Appendix 4 – Consultation Responses from internal and external agencies

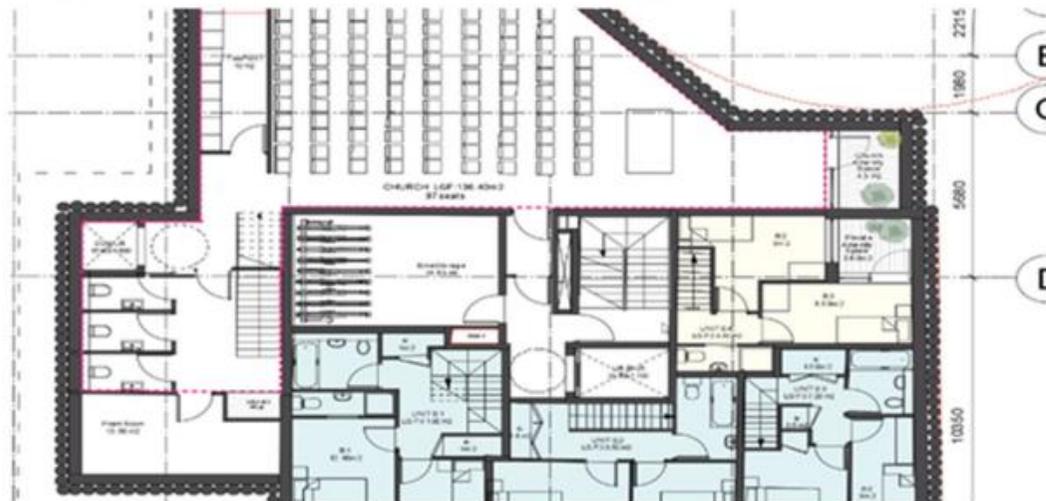
1. The drawing plans show a door between a church hall and residential communal area. We would like clarity on the access point between the church hall and residential units will be used for.

This door provides a means of escape only. It will be secure and not used for any other purpose.
